FINAL DRAINAGE REPORT

**FALCON FIRE STATION NO. 3
7030 OLD MERIDIAN ROAD, FALCON, CO 80831**

**JPS Project No. 042001
PCD Project No. __-20-__**

Add PCD File No. PPR-20-024

Detention Basin Outlet Structure Design

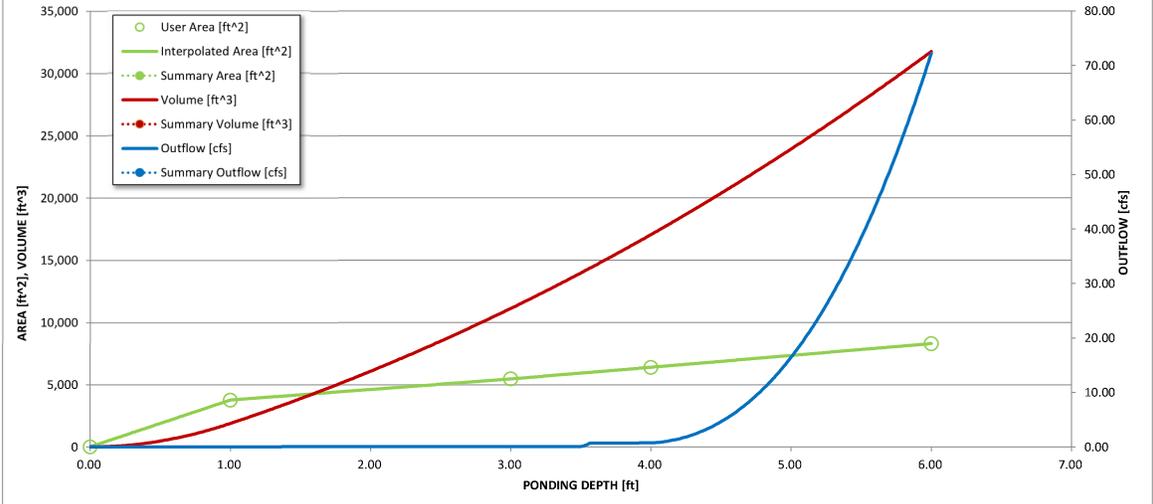
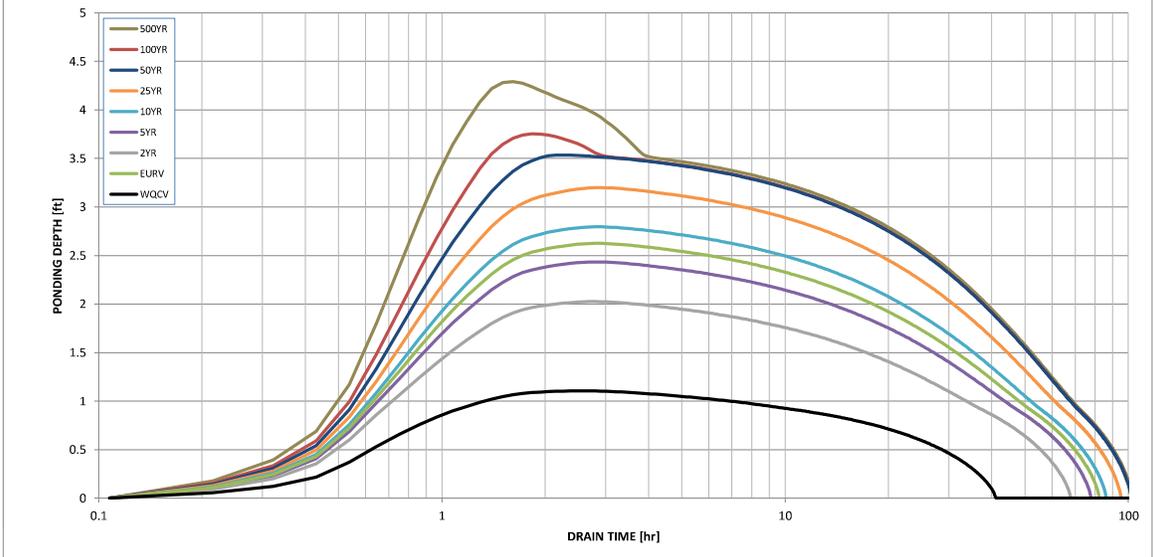
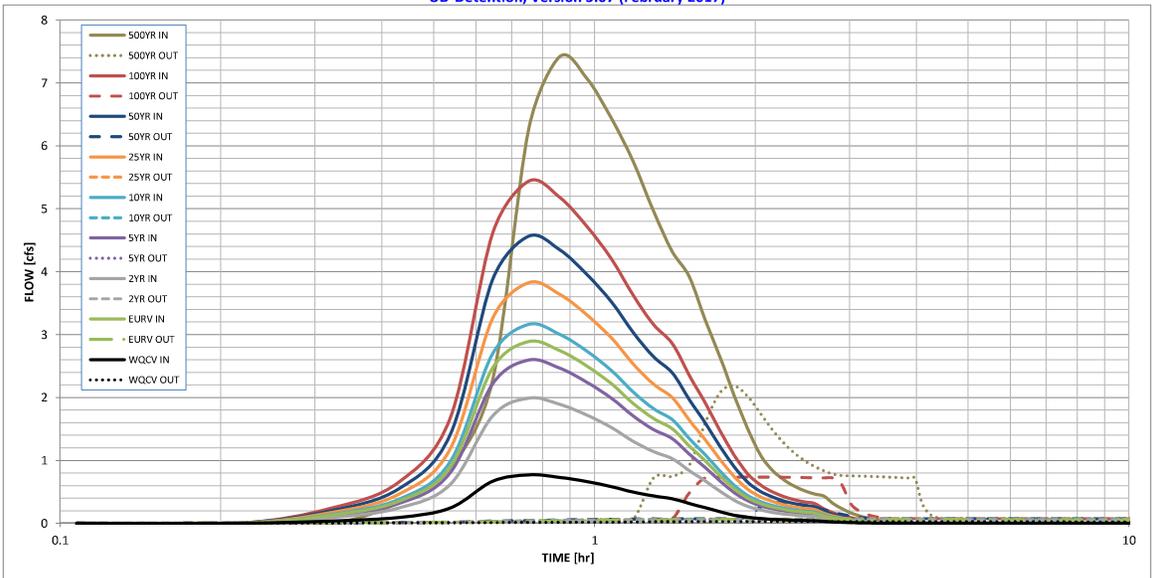
Provide a footnote or narrative with justification for being out of specification, or revise. Call to discuss if needed.
Jack Patton (719) 505-0236.

Please use the updated version 4.03 (May 2020)
